Director-General's Report

**Modification to Minister's Approval for a Mixed Use Subdivision at
Lot 144 DP 1030322, Lot 3 DP 1042119, Lot 13 DP 1014470, and Part
Lot 223 DP 1048494 – Tweed Coast Road, Casuarina Beach**

Major Project 06_0258 MOD 2

Figure 4: Proposed Project Staging Showing Stage 1A (shown in light blue) and the Balance of Stage 1 Works (shown in yellow) (source: Section 75W Modification Report)

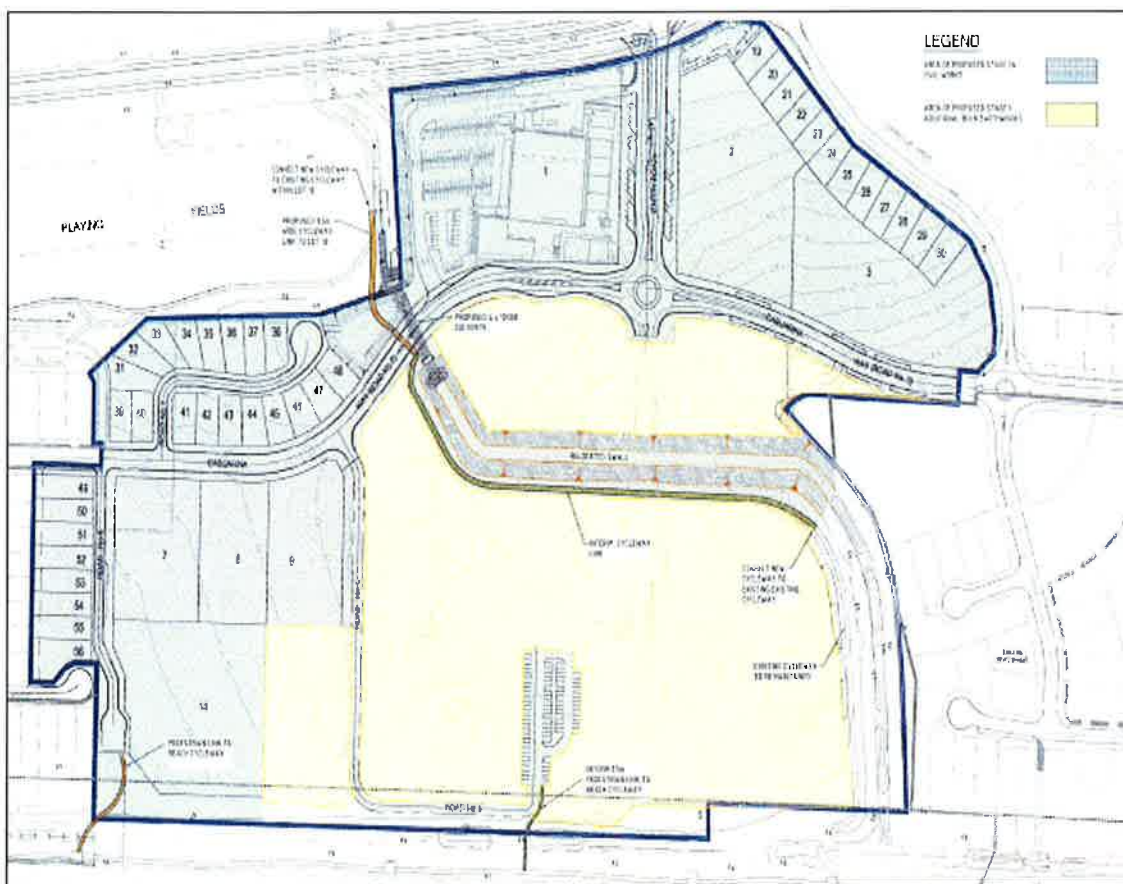
Other than the interim Stage 1A works as listed above, the balance of Stage 1 works will be all remaining works carried out as originally approved, which includes the construction of the retail centre (consisting of a supermarket and retail stores) on Lot 1. **Figure 4** below identifies the proposed staging of the project application. **Figure 5** outlines the location of works to be undertaken as part of proposed Stage 1A, including Road No.5 and car parking area; the reconfigured drainage swale; pedestrian access links to the north-south beach cycleway; cycleway connections to existing infrastructure to the east and west of the site; and, the location of drainage culverts.

The Department considers that the proposed modification will not alter the approved form of the Casuarina Town Centre, but will instead result in a more logical sequence of providing the necessary infrastructure and services in accordance with the project staging. The proposal to construct approved Stage 1 in two separate sub-stages will see the eastern half of Boulevard road not constructed until such time that this section of road is actually required as part of future stages. This will subsequently reduce the potential for anti-social behaviour (such as hooning) as this stretch of road would otherwise become largely underutilised until such time that future stages are developed. Furthermore, public funds will not be required to maintain and upgrade road infrastructure, other public services, and landscaped areas that are not yet being utilised.

Council has advised that the Proponent's justification in requesting the modification is considered legitimate and is satisfied that all necessary public infrastructure will be available to service the ongoing staging of the development. Council subsequently supports the Proponent's rationale to provide infrastructure only when required and there were no objections raised in regards to the modification request. A copy of Council's correspondence is included at **Appendix D**.

Figure 5: Proposed Works as part of Stage 1A (source: Section 75W Modification Report)

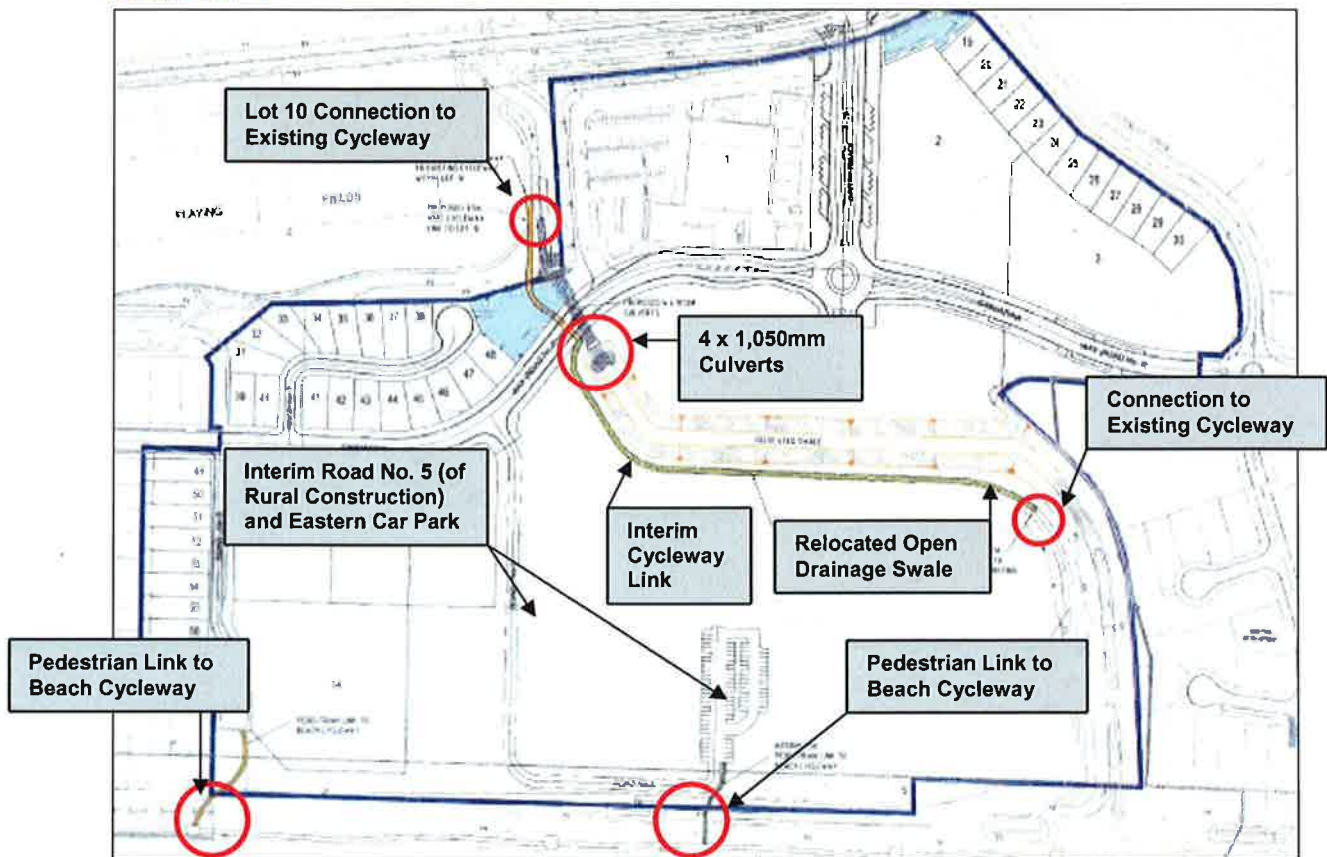
In particular, proposed Stage 1A works will involve:

- all bulk earthworks across the site;
- subdivision of land and civil works limited to Lots 1-3, 7-9, 14, and 19-56 only;
- civil works along the new Casuarina Way road connection;

- construction of the western section of the Boulevard Road, including a U-turn bay within the central landscaped median and a two-lane roundabout at the intersection of the Boulevard Road and Casuarina Way;

- Road No. 5 and Road No. 6 (with Road No. 5 constructed to a temporary rural standard);
- minor reconfiguration of the north-south drainage swale and maintaining the swale as an open drainage feature;

- 4 x 1,050mm culverts beneath Casuarina Way at the southern end of the reconfigured swale, discharging to the adjoining Lot 10;
- a 3.5m wide cycleway link to the existing cycleway at adjoining Lot 10;

- an interim cycleway link connecting from the existing east-west cycleway and running parallel to the relocated swale, ultimately connecting to the existing cycleway at adjoining Lot 10;

- a car park to be located at the northern end of Road No. 5 (not kerbed, rural-type construction), with a 1.5m wide interim pedestrian link to the existing cycleway running parallel to the eastern site boundary ; and,

- a pedestrian link from the eastern end of Road No. 6 to the existing cycleway running parallel to the site's eastern boundary.

Figure 7: Catchment Areas and Drainage Paths as Proposed under Stage 1A (source: Section 75W Modification Report)

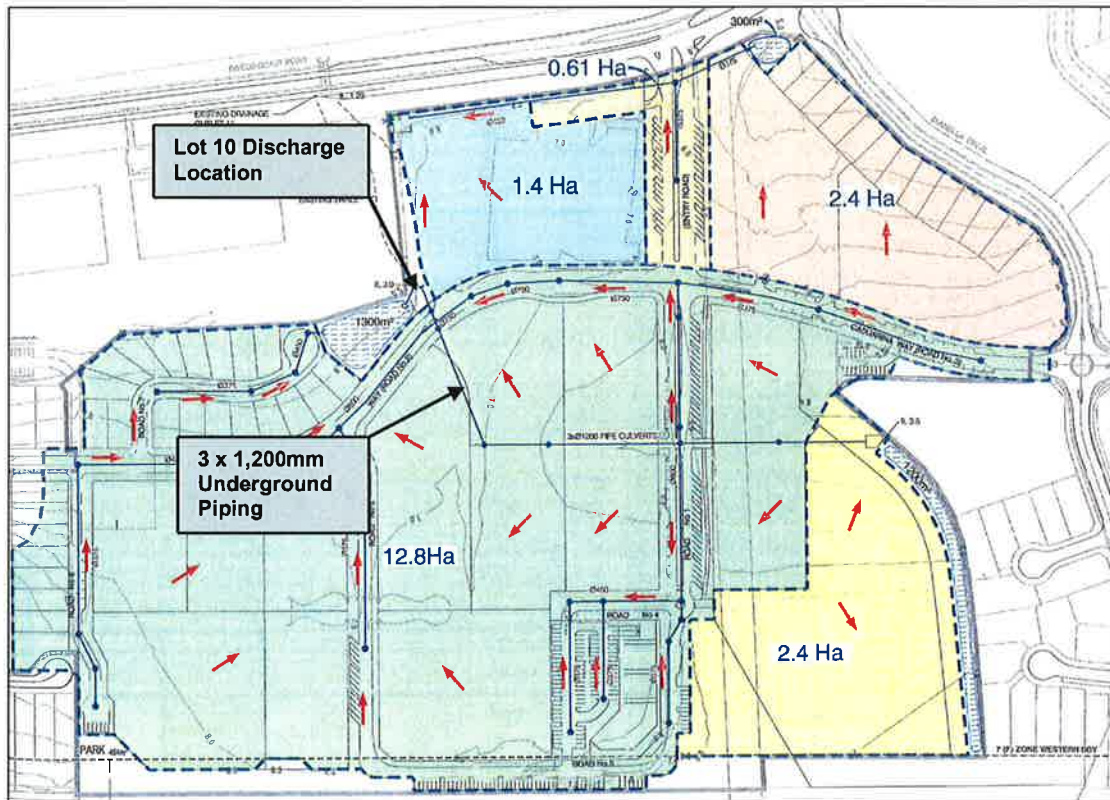
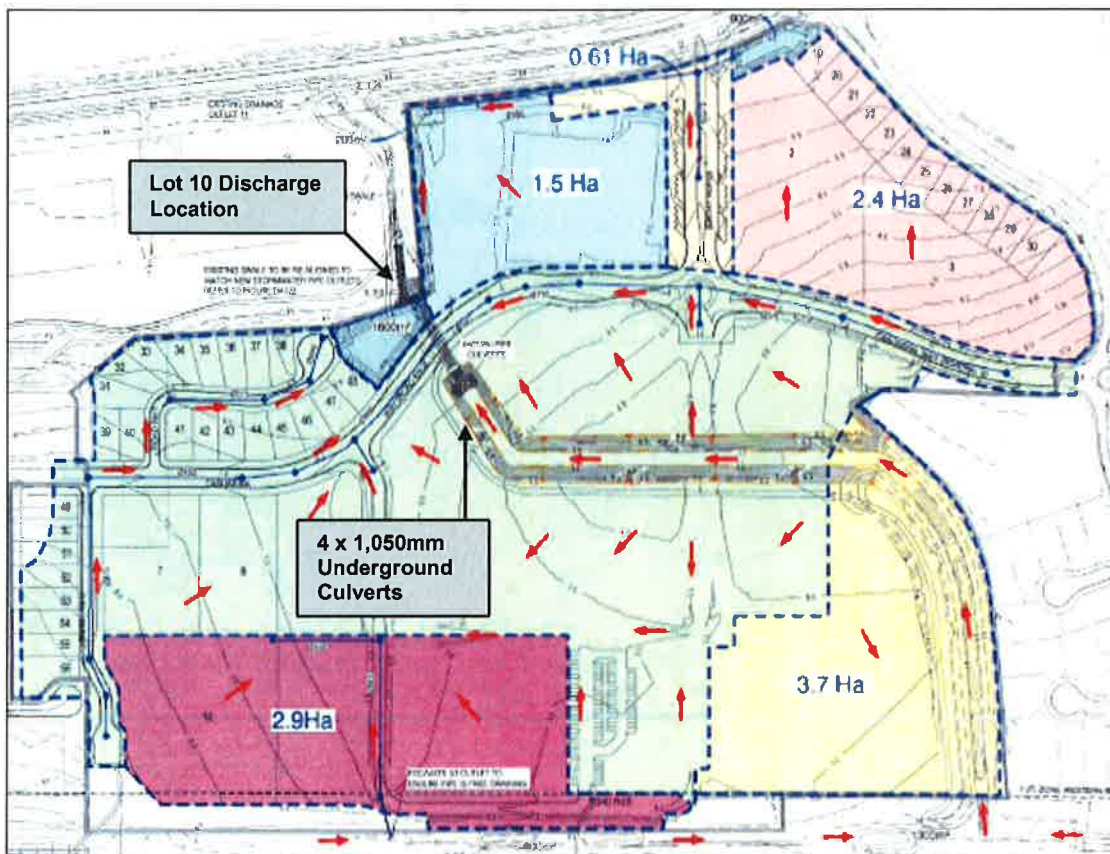
The proposed minor relocation of the drainage swale and decision to maintain the swale as an open drainage feature until such time that Stages 2 to 4 are to be developed will result in a slightly modified stormwater drainage regime for the site. The approved stormwater regime consists of five sub-catchments across the site draining to three detention basins. The modified stormwater drainage regime is a temporary measure and consists of six sub-catchments draining to two detention basins as well as the open drainage swale. **Figure 6** below illustrates the catchment areas and drainage paths for the approved layout, which shows the north-south drainage swale replaced with three 1,200mm underground pipes which discharge to Lot 10 at the western boundary of the site. **Figure 7** illustrates the modified catchment areas and drainage paths as proposed under Stage 1A, with the drainage swale maintained as an open drainage feature and four 1,050mm culverts diverting drainage collected within the swale beneath Casuarina Way and discharging at Lot 10 adjoining the western site boundary.

Maintaining the swale as an open drainage feature will see the swale continue to function, albeit temporarily, as an open space corridor and vegetated buffer to properties adjoining the northern site boundary. Given the stormwater drainage regime across the site will not be compromised by the proposed modification, the Department does not raise any concerns in regards to the relocation of the swale and decision to temporarily maintain the swale as an open drainage feature. Furthermore, Council's engineers raised no concerns in regards to stormwater management at the site.
